FINAL SITE GRADING CONSTRUCTION PLANS  
FOR  
**CARRIAGE MEADOWS SOUTH at LORSON RANCH**  
FINAL GRADING / EROSION CONTROL PLANS

**COVER SHEET  
FINAL SITE GRADING  
AND EROSION CONTROL PLANS**

DATE  
**JUNE 20, 2017**  
PROJECT NO.  
**100.030**  
SHEET NUMBER  
**C0.1**  
TOTAL SHEETS: **17**

**SF 17-011**

DATE	JUNE 20, 2017
PROJECT NO.	100.030
SHEET NUMBER	C4.3
TOTAL SHEETS:	17

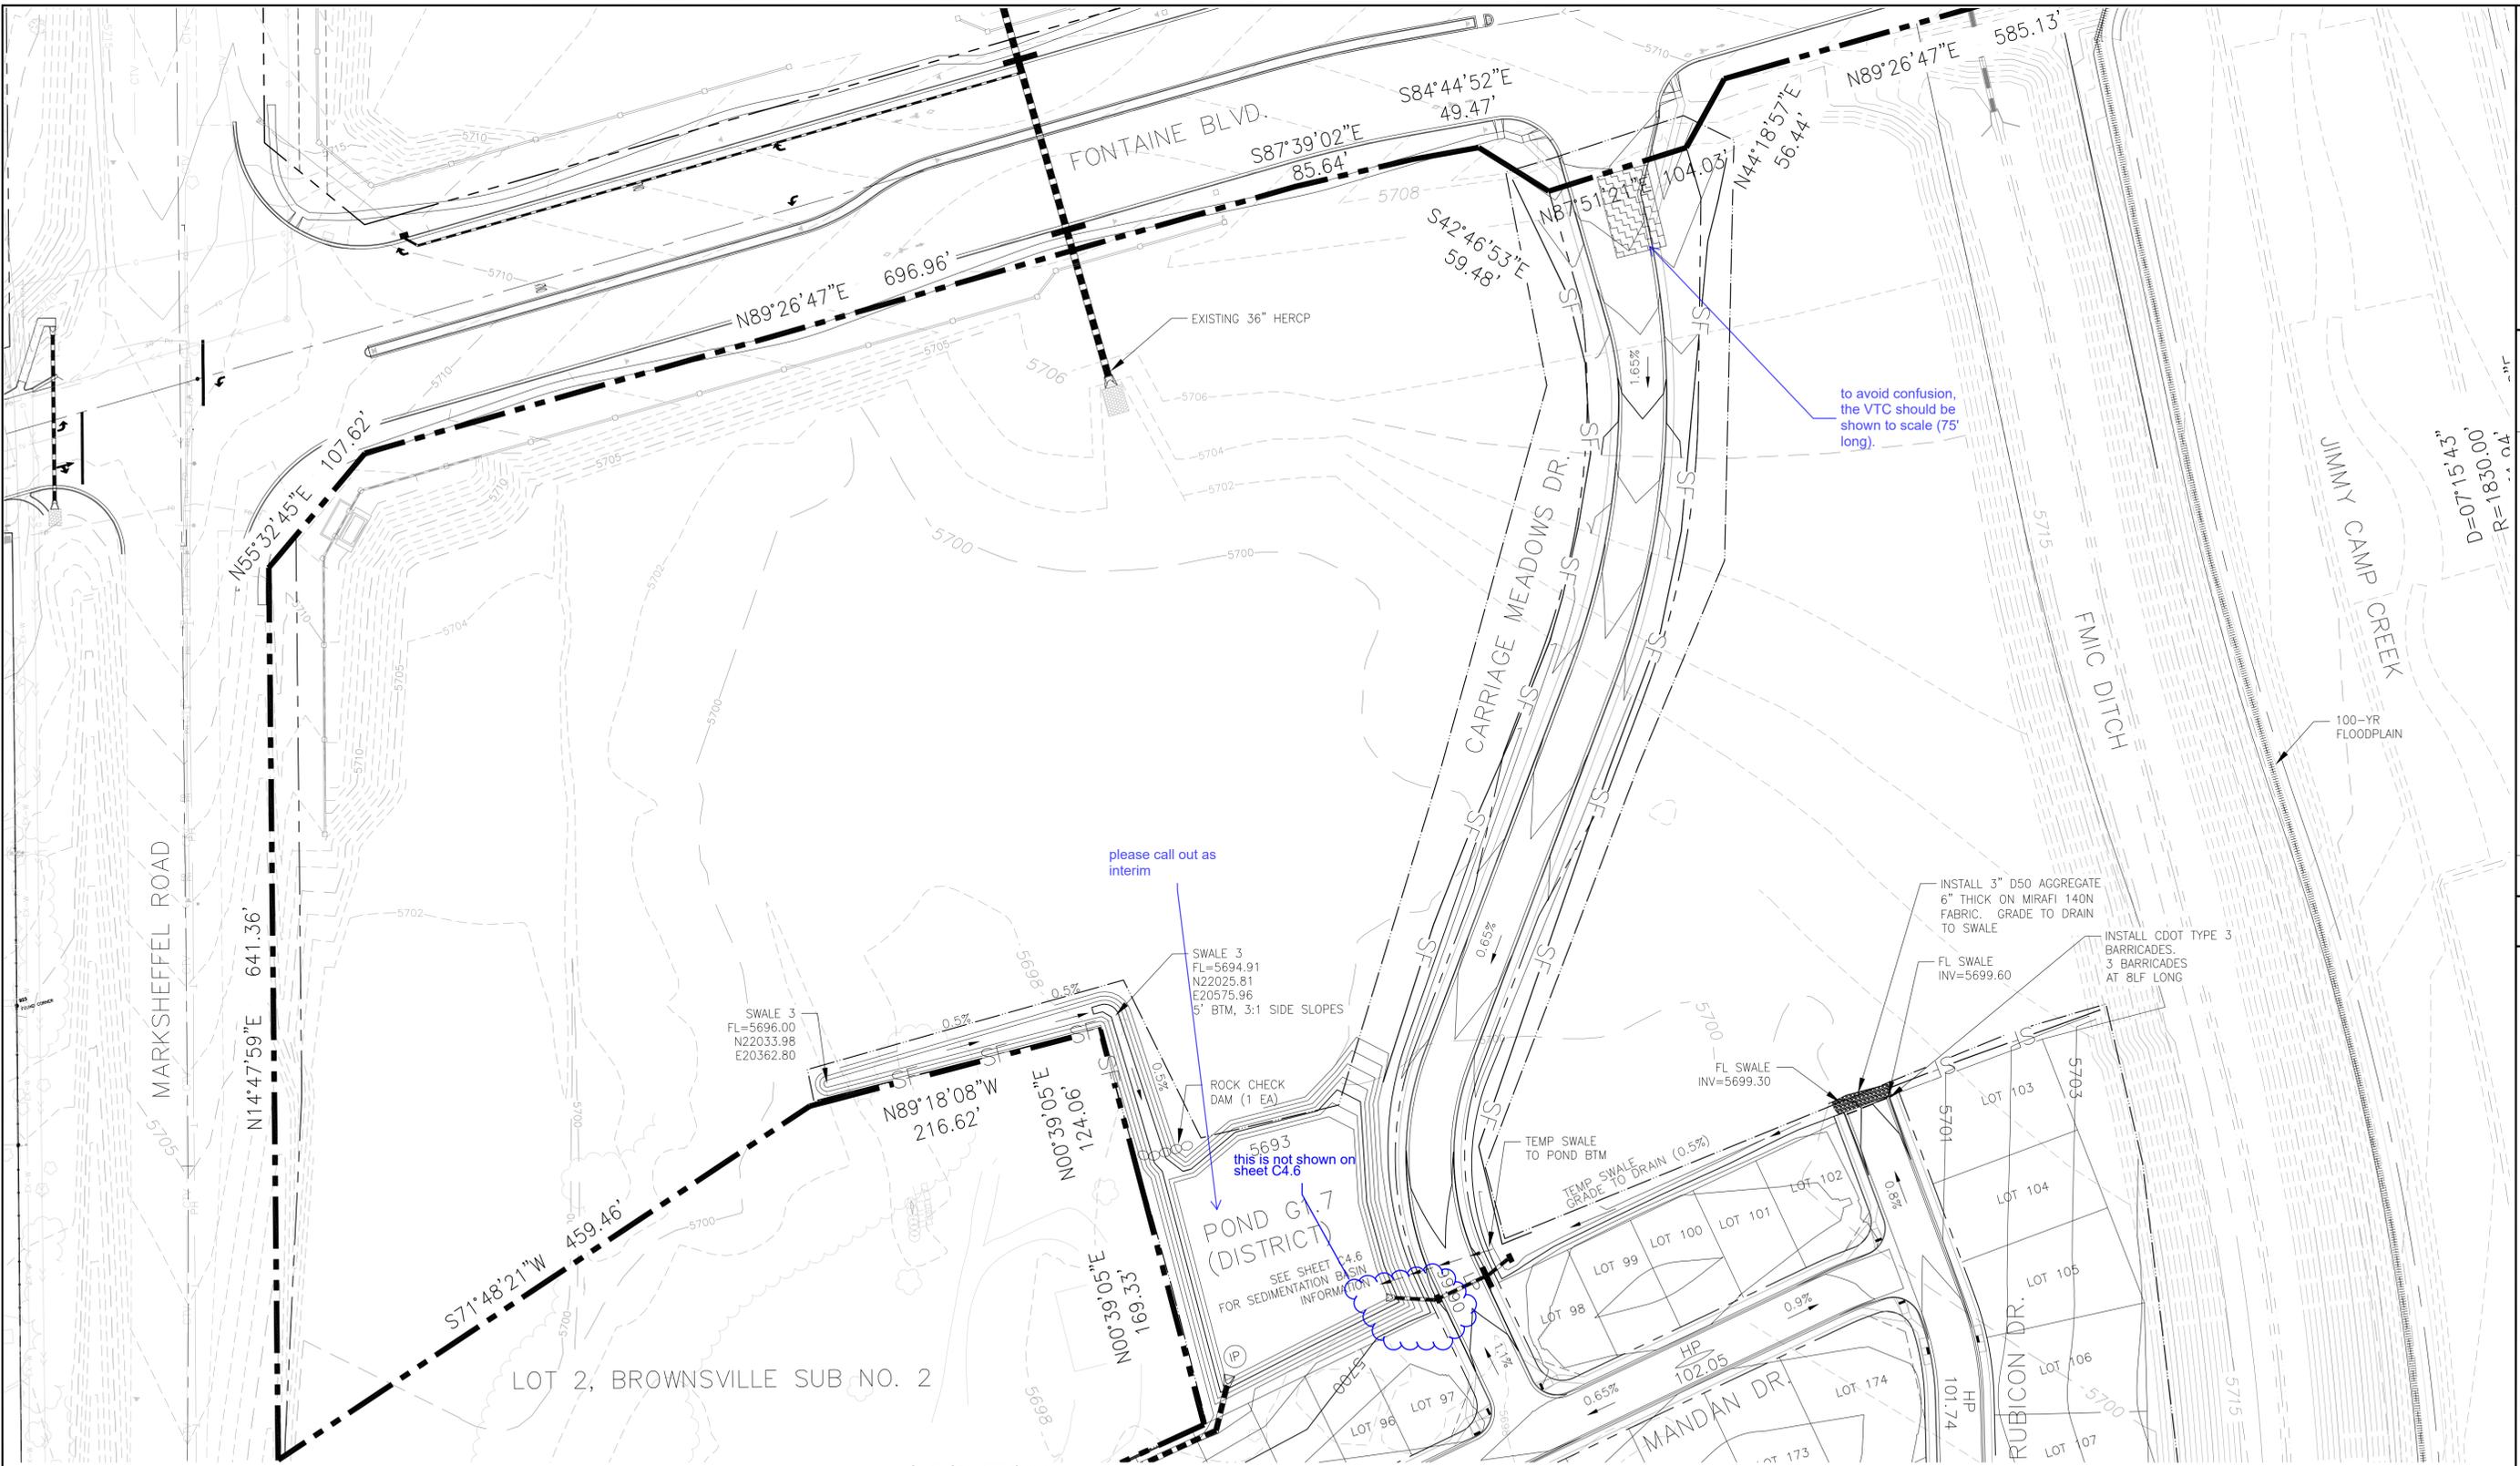
is this intended to be swale G1.8? Please correct each sheet.

SHEET NUMBER C4.7

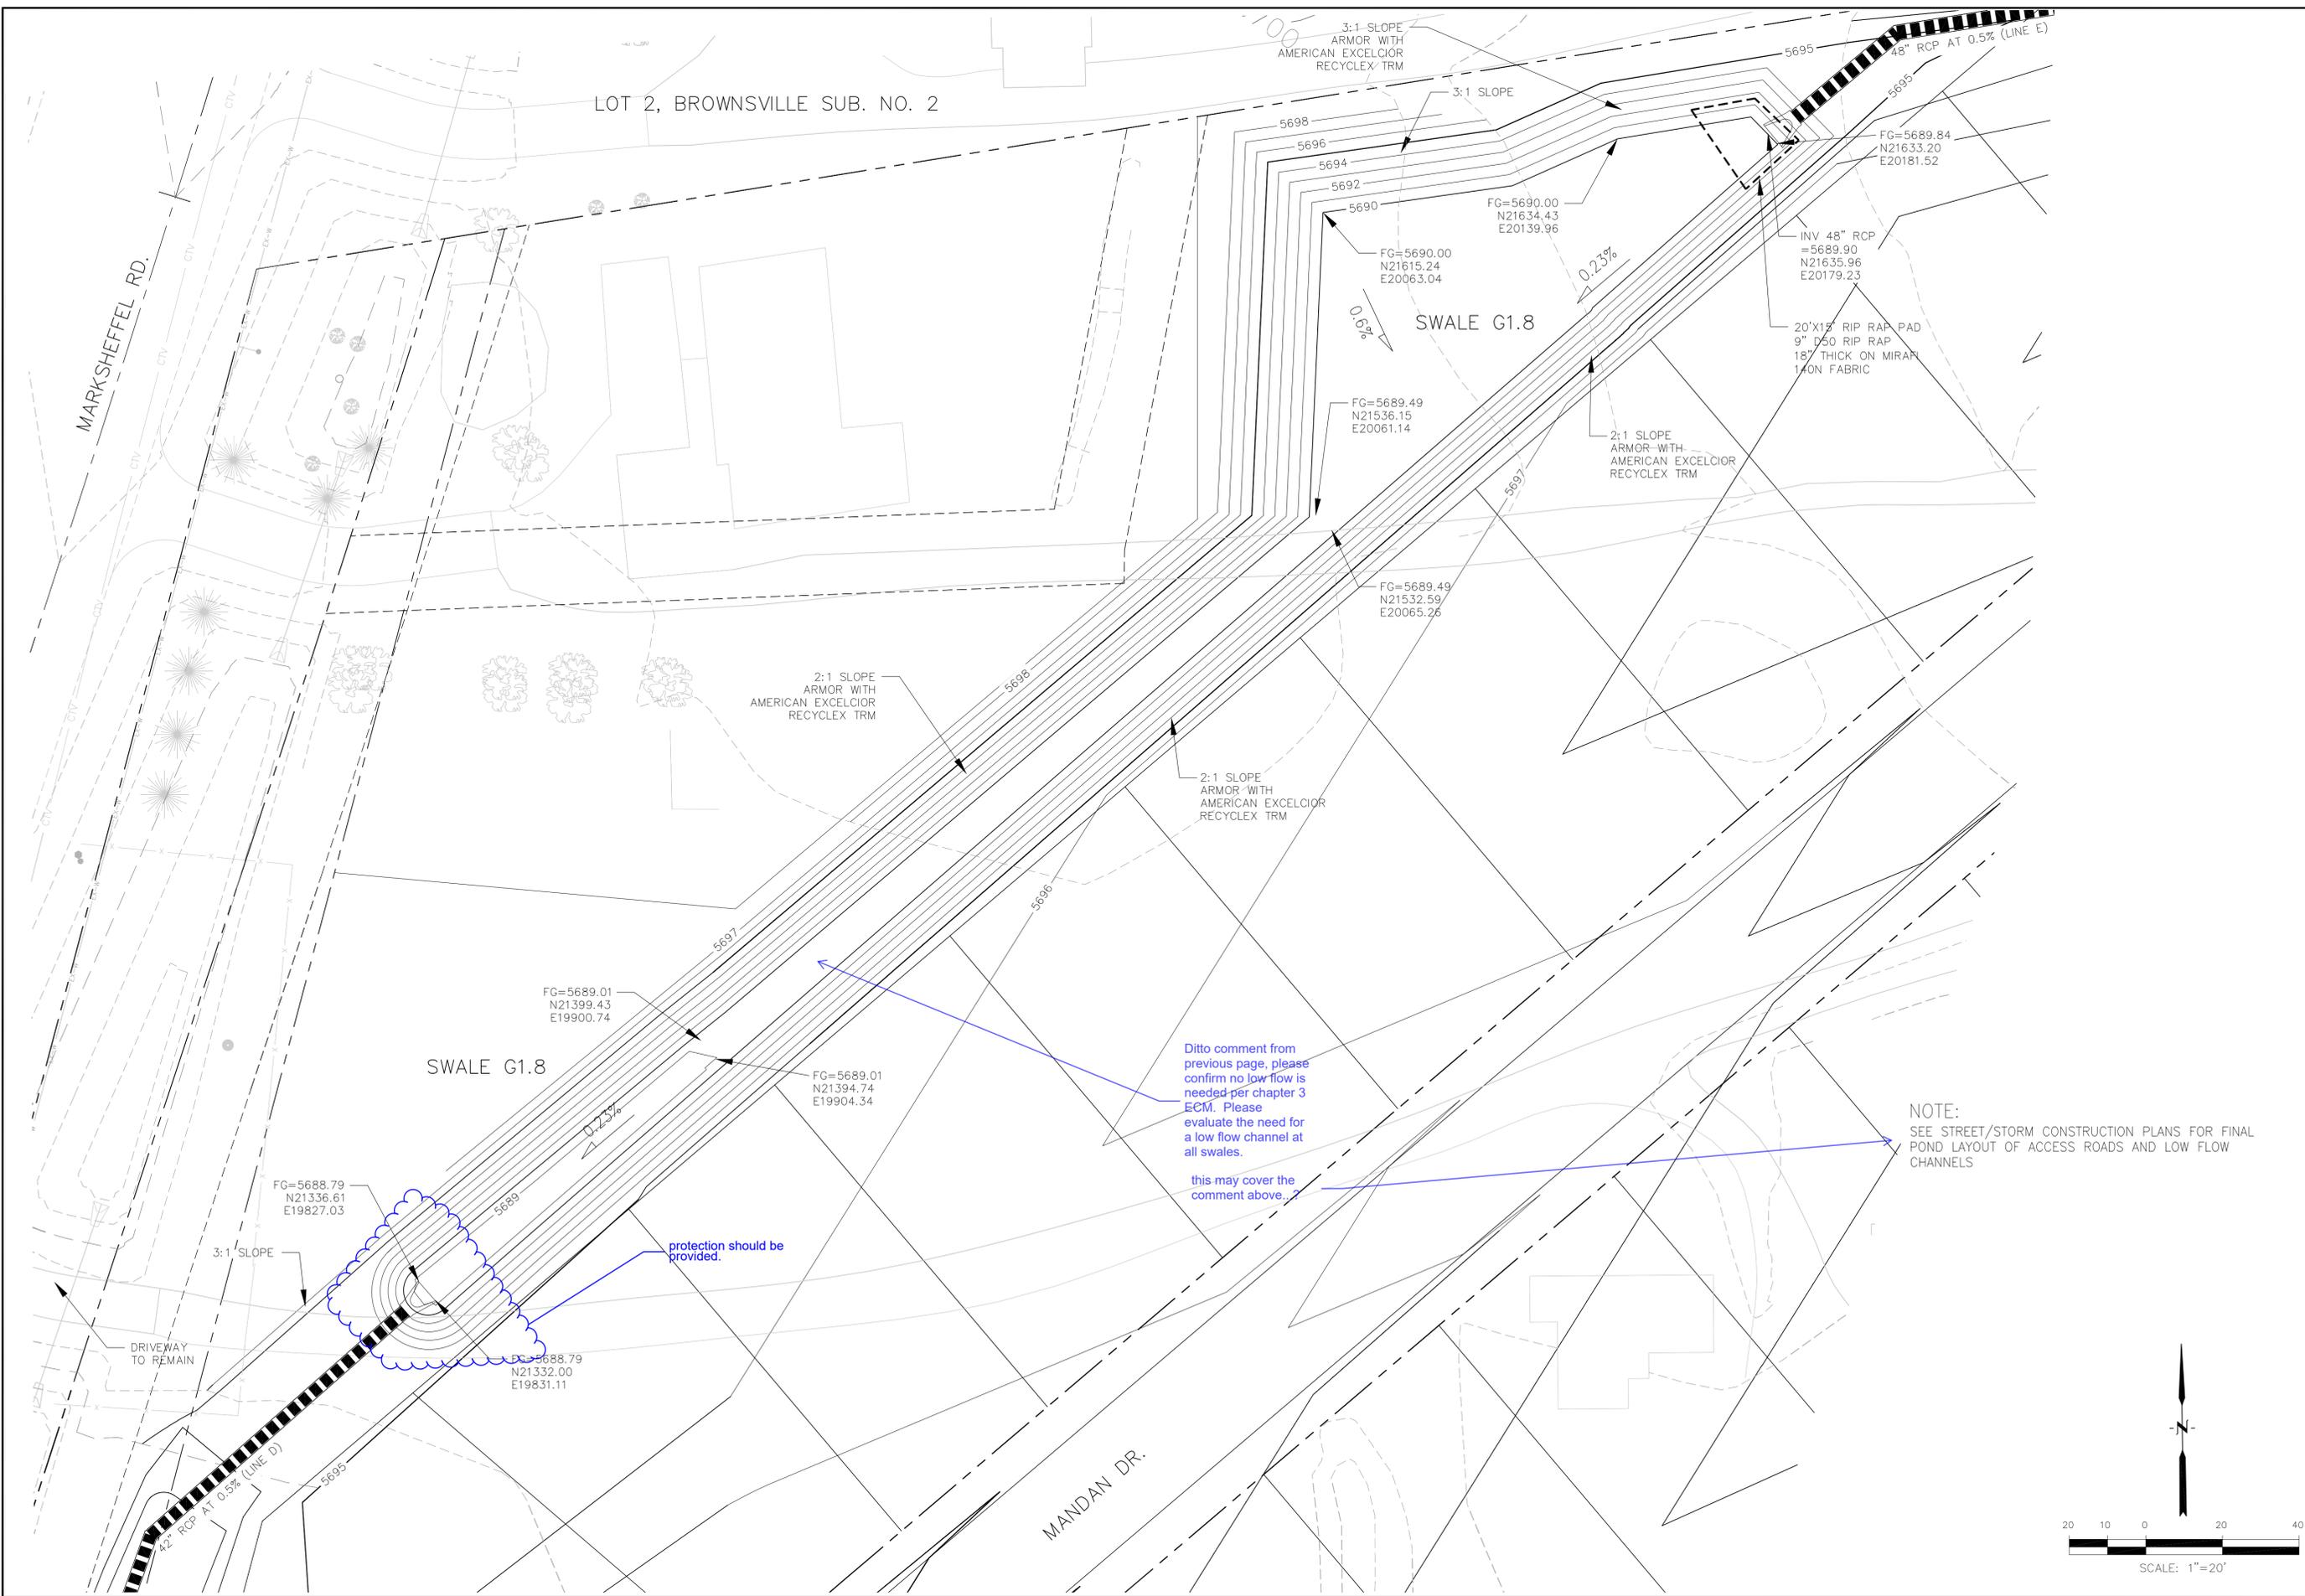
Ditto comment from  
previous page, please  
confirm no low flow is  
needed per chapter 3  
ECM. Please  
evaluate the need for  
a low flow channel at  
all swales.

this may cover the  
comment above.

protection should be  
provided.

**DETENTION POND G3 (DISTRICT)**  
**CARRIAGE MEADOWS SOUTH**

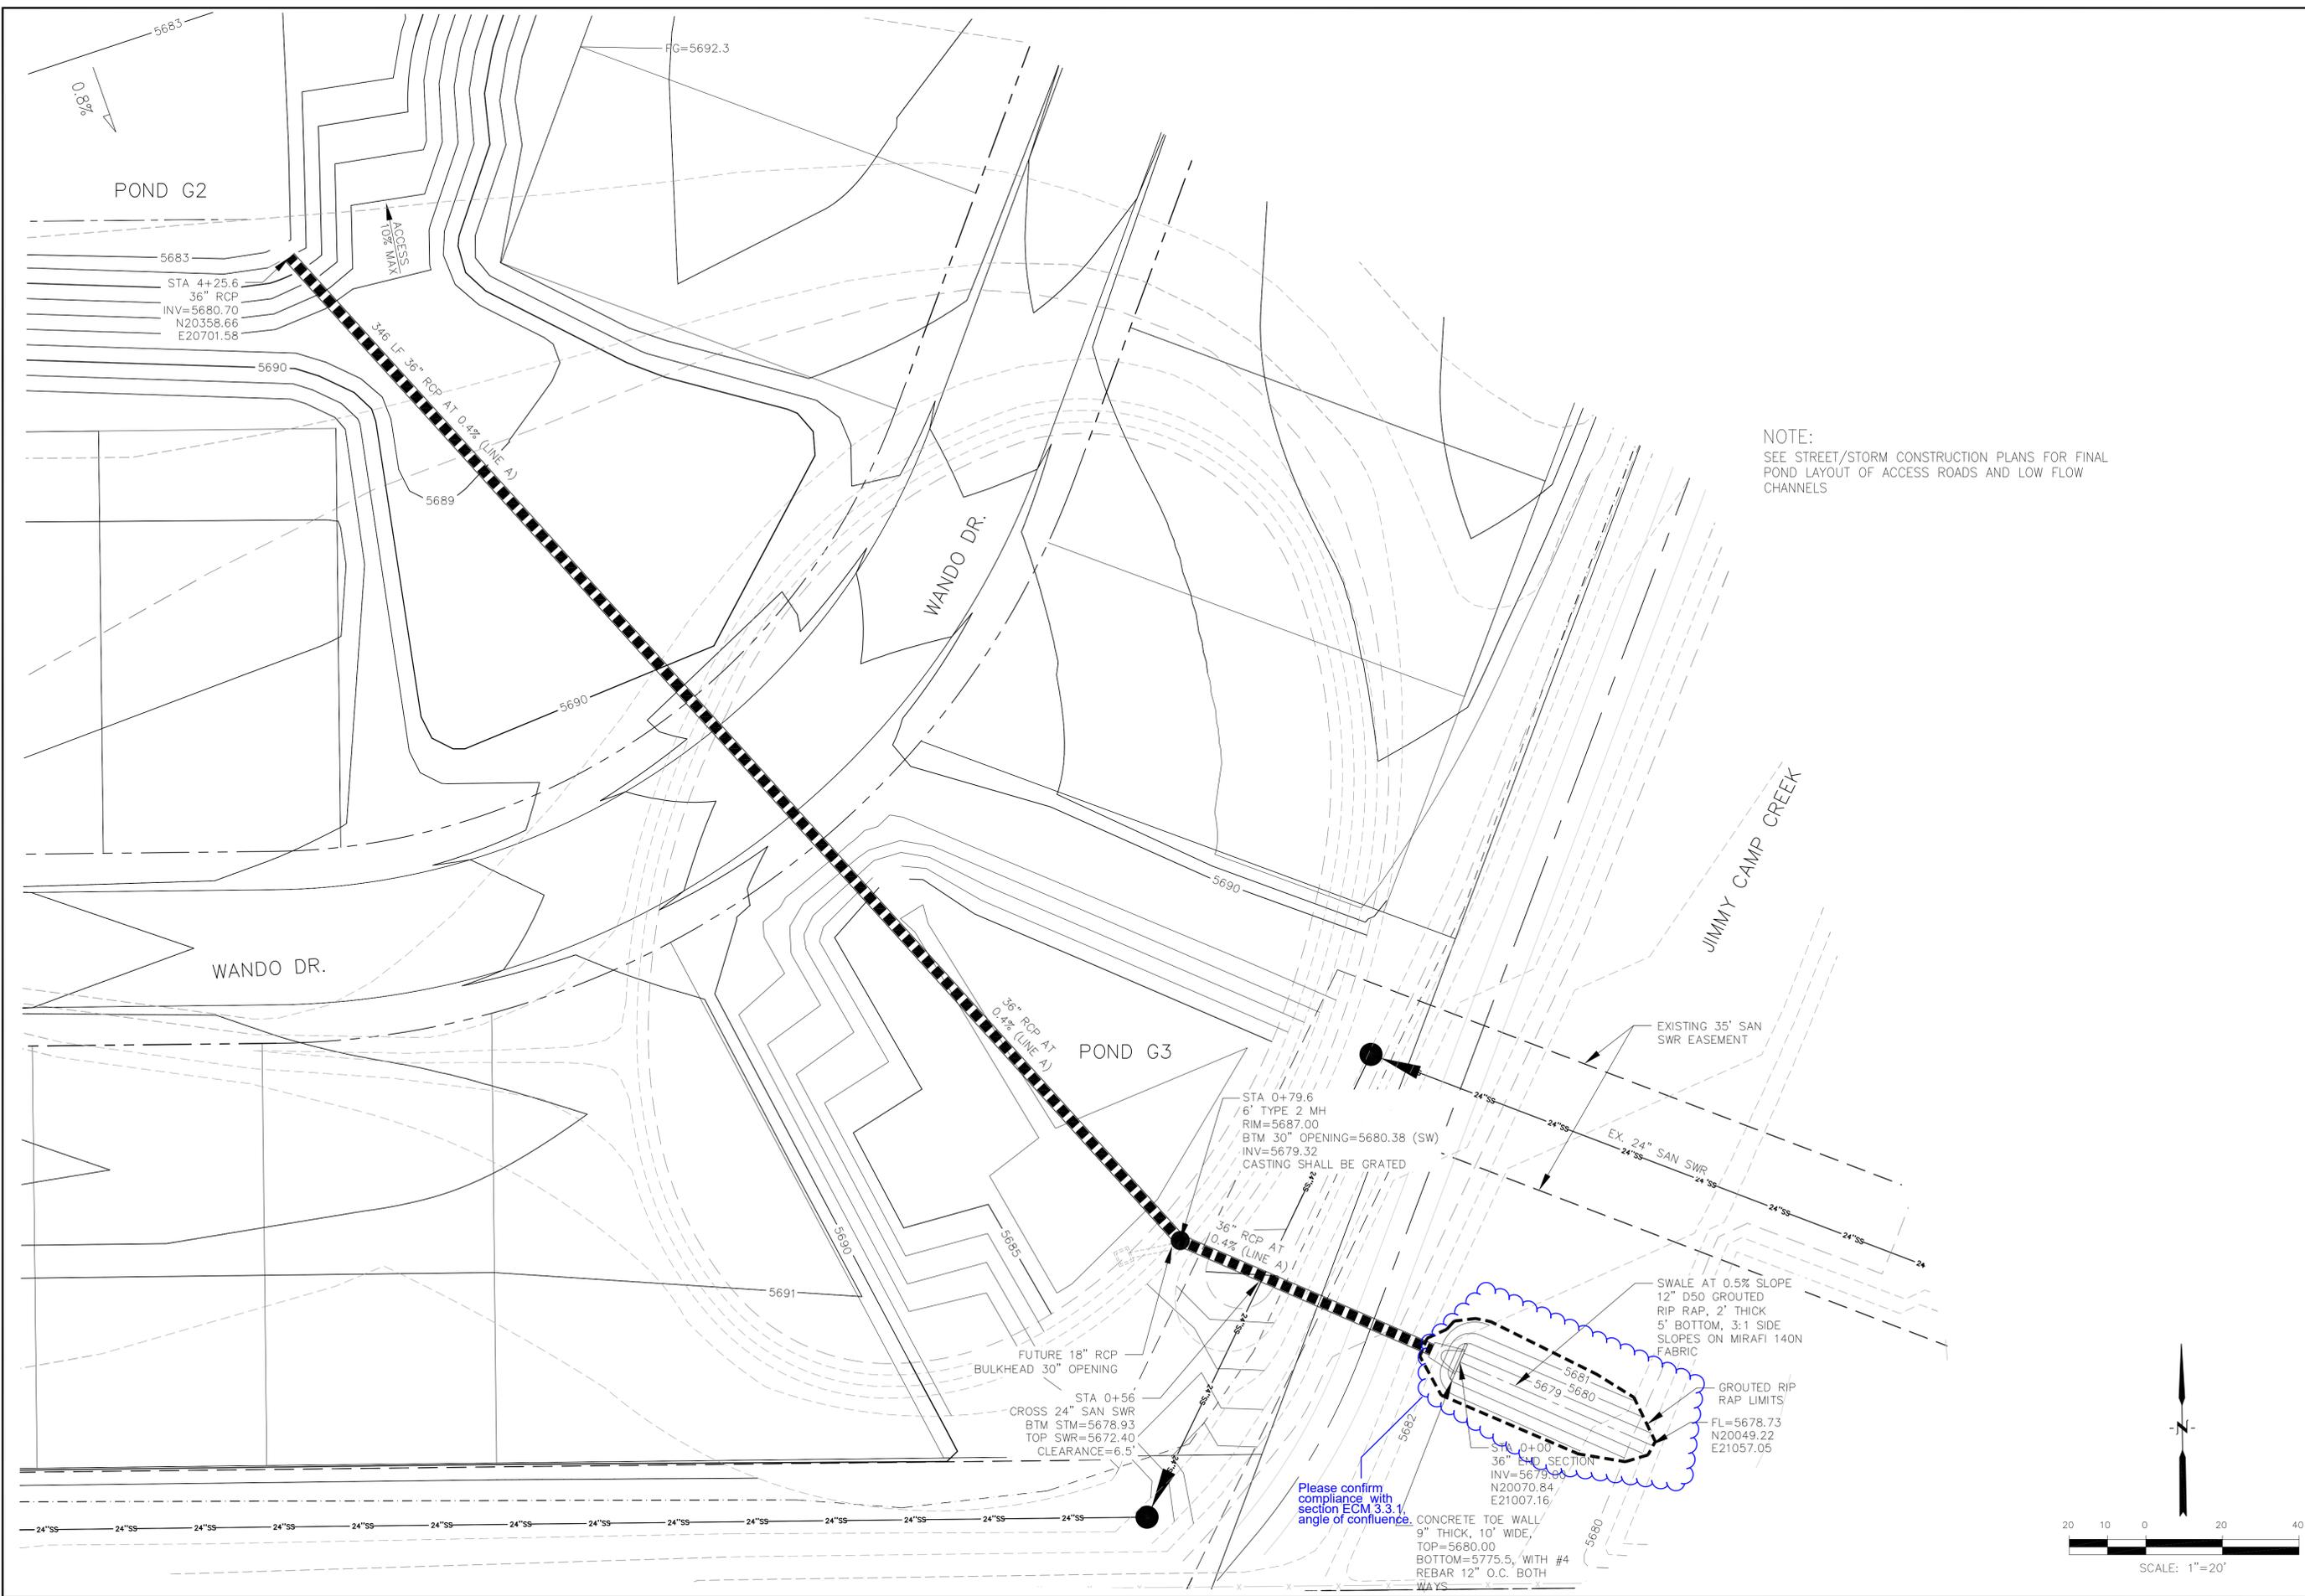
is this still valid? or is  
 it from the overlot  
 grading? typical all  
 locations, please call  
 out the removal of the  
 interim system to  
 allow for construction  
 of the permanent  
 structures.
